1962 Corvette: Service Bulletin: Aluminum Powerglide Shift Problems

Subject: Aluminum Powerglide Shift Problems

Model and Year: 1962 Passenger, Chevy II and Corvette

Bulletin No: DR #514

FIGURE 1- 327 AND 283 POWERGLIDE TV LINKAGE COMPARISON

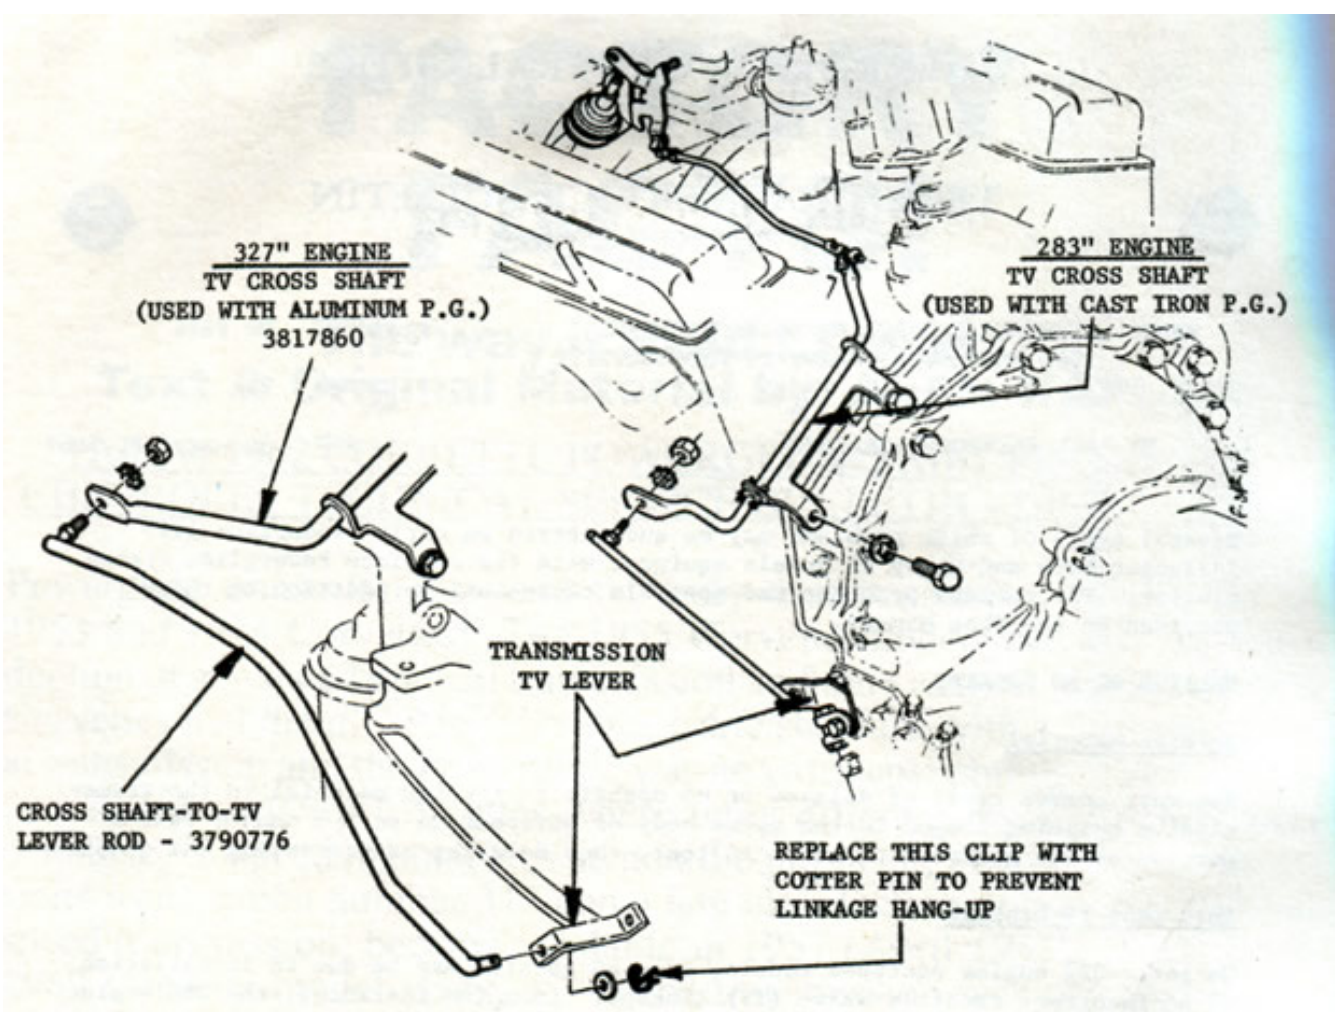
Incorrect TV Linkage

On early 327 engine equipped models, delayed upshift may be due to installation of an incorrect throttle valve (TV) linkage. In a few instances, the 283 engine cross shaft was installed instead of the correct TV cross shaft, 3817860. The TV cross shaft are easily identified as the 283 version has a bend in its outboard lever whereas the 327 cross-shaft lever is straight in this same area. (Figure 1). If the TV cross shaft was incorrect, also check the cross shaft-to-TV lever rod. As shown in Figure 1, this rod, 3790776, is formed on 327 engine applications as compared to the straight rod used on 283 engine versions.

Cross Shaft, TV (327 engine) ---- 3817860

Rod, Cross Shaft-to TV (327 engine) ----- 3790776

FIGURE 2 - ALUMINUM POWERGLIDE DIPSTICKS

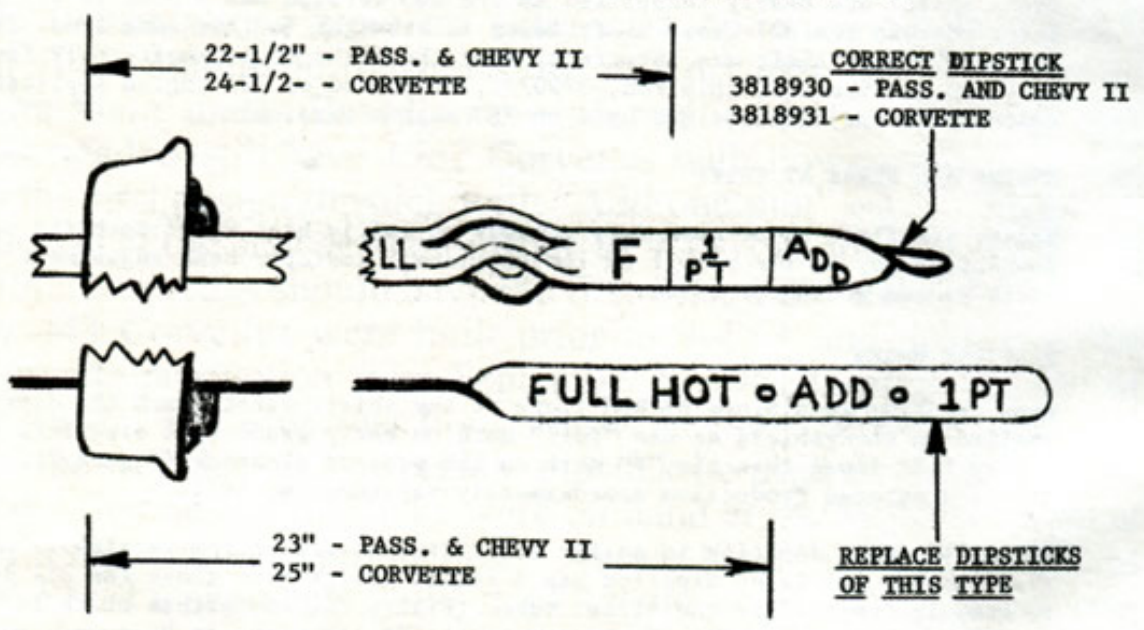
Dipstick Usage

When checking complaints of RPM flare at the shift, first check the dipstick installed in the vehicle as the "Full" mark on early production dipsticks is approximately 1/2" lower than the "F" mark on the present dipstick (Figure 2). The later dipstick entered Production approximately September 4, 1961.

The early style dipstick is easily identified as its bottom section is absolutely flat whereas the later dipstick has a formed bridge just above the oil level markings to keep it centered in the filler tube. (Figure 2). A further check is to measure the distance from the top of the cap to the "Full" mark; on

Passenger and Chevy II dipsticks, this distance is now 22-1/2", as compared to 23" on the earlier dipsticks. This distance on the Corvette dipstick is now 24-1/2" as compared to 25" on earlier units.

Replace all early dipsticks with the later part when found and add oil as

required to raise the transmission oil level to the "F" mark. The later dipstick for 327 engine passenger cars and all Chevy II Models is 3818930; for Corvette, 3818931.
